## CITY OF KIRKLAND NOTICE OF DECISION

**Permit application:** HBG Market Short Plat, File No. [SUB15-01895](#)

**Project description:** Subdivide one parcel of 0.41 acres into two separate parcels in the RS 7.2 Zone (see Attachment 2).

**Department Decision:** **Approval with Conditions**

**ATTACHMENT 1, PROPOSED TREE PROTECTION FENCE EXHIBIT**

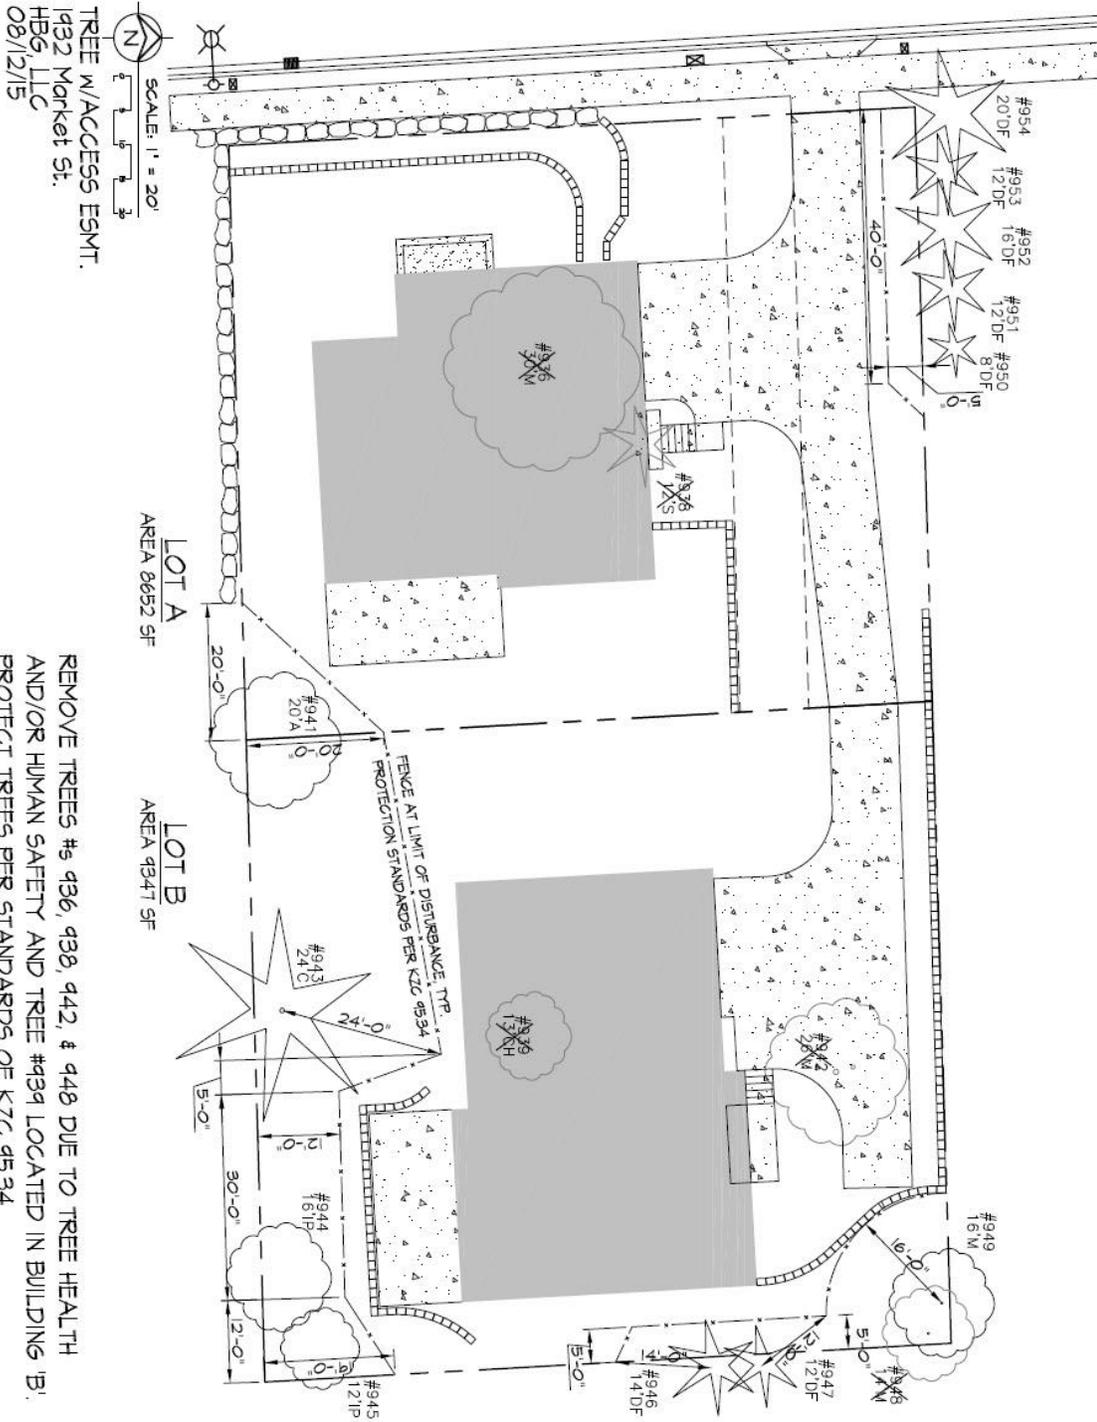
As you requested, I have reviewed the proposed *Tree Protection Fencing* diagram/site plan that you sent to me on Friday, August 28, 2015. You requested that I review the placement of the fencing to determine whether or not it meets the requirements of the Kirkland Code and will in fact the location of the fencing likely result in the preservation of the trees. (Please refer to *Attachment 1, Tree Protection Fencing Plan* for an orientation to the site and the location of the fences in relation to the trees.)

*After reviewing the Fencing Plan, it is my judgment that the plan does in fact meet the needs of the Code and will support long-term tree survival.*

**SUMMARY STATEMENT:** *After reviewing the proposed Fencing Plan, it is my judgment that the plan is consistent with the information in my tree report and is consistent with the meetings we had on site to discuss the conflicting demands required to build. It is my judgment that this proposed Tree Protection Fence Plan does in fact meet the needs of the Code and will support long-term tree survival.*
